## 11.2.2 LIMESTONE CLIFF STABILITY ASSESSMENT

<b>LOCATION/ADDRESS</b>	Shire of Augusta Margaret River
<b>APPLICANT/LANDOWNER</b>	Shire of Augusta Margaret River
<b>FILE REFERENCE</b>	ENV/128
<b>REPORT AUTHOR</b>	Jared Drummond, Sustainability Planning Officer
<b>AUTHORISING OFFICER</b>	Dale Putland, Director Sustainable Development

**Site ID: PR4 - 30 (Surfers Point)**

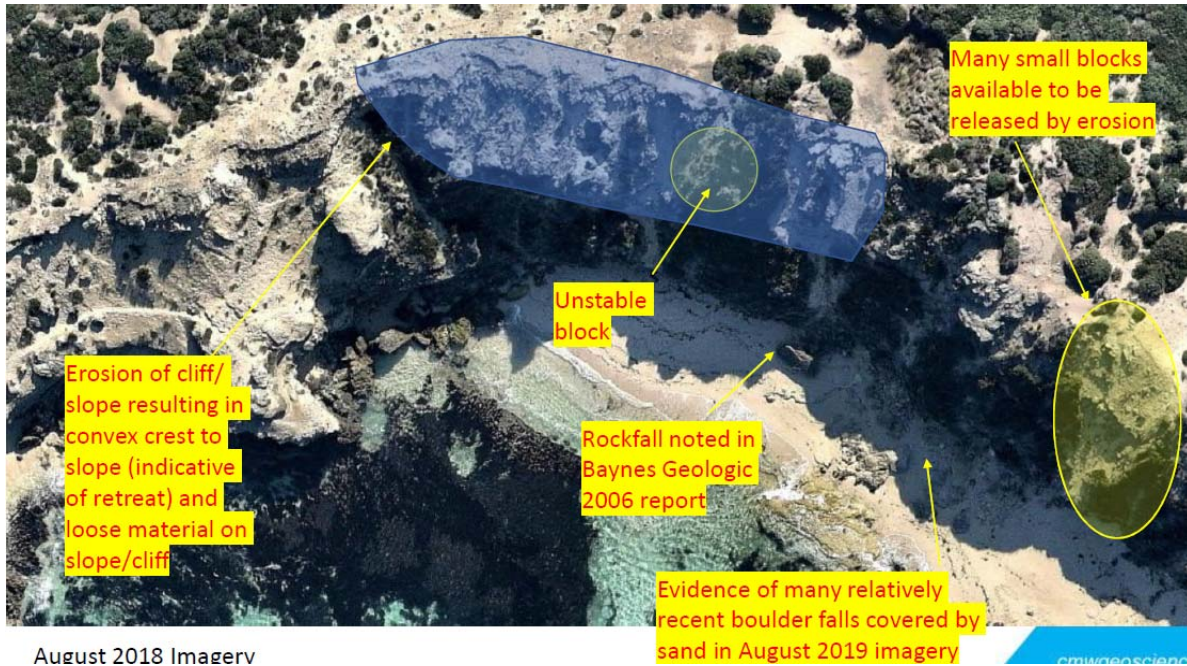
A cliff outcrop/overhang exists mid-way down the cliff face of Surfer's Point directly adjacent to the stairway. To reduce the risk from potential collapse of the overhang, the 2017 report recommended removing the viewing platform and beach midway down the stairway. The viewing platform was removed on this basis (see image below). The scope of works (for this study) required an analysis to be undertaken to determine the resultant risk to public from the overhang and response required (if any). The study also provides advice on the most suitable measure to address risk mitigation, should the Shire wish to re-install the platform in the future.

Removal of the bench and lower viewing platform resulted in the main risk now coming from people sitting on top of the outcrop during surf events or at other times, rather than a risk to people using the stairway. The recommended mitigation response in the report is to underpin the overhang using mass concrete and architectural block work. This not only supports the overhang from collapse but also protects the overhang from future wind erosion. The consultant advised that should this be undertaken it would be safe to re-instate the viewing platform in the future.

Lower lookout and bench removed since 2017

Approximate extent of undercut block caused by wind eroding out leached limestone/sand layer

The report assumes that up to 20 people use this area during events up to two times each year, resulting in a significant risk to large numbers of the public. Numbers of this proportion were reported in the past, associated with surfing events. During the Surf Pro in May, one person was spotted using the concrete plinth below the overhang (where the viewing platform was previously located) as a camera location. One person was also recorded sitting atop of the overhang. The very low number of people recorded at this site reduces the risk of people being impacted from rockfall collapse. This area is highlighted as an exclusion zone for any events at Surfer's Point, with relevant development approvals prohibiting public from accessing this area. This may have contributed to reduced numbers recorded at this site. However, a significant risk remains to people who may use the area when crowd control is not present.

Further risk mitigation works have commenced, with the first stage including installation of additional cliff safety signage, followed by extension of the balustrading. These works are intended to provide added protection to public and substantiate the exclusion zone. It should be noted that if the underpinning works do not proceed the risk of cliff collapse remains, which could result in retreat of the cliff face due to collapse and subsequent erosion.

In response to the above, it is recommended that the Shire manage this risk through preventive means (i.e. development approval conditions, signage, extended balustrading, inspections, monitoring during surf events etc.) rather than underpinning as recommended in the report. Underpinning may be required in the future if increased visitation is recorded at this site, but will be subject to ongoing monitoring. If required, underpinning could be implemented as part of future budget considerations.
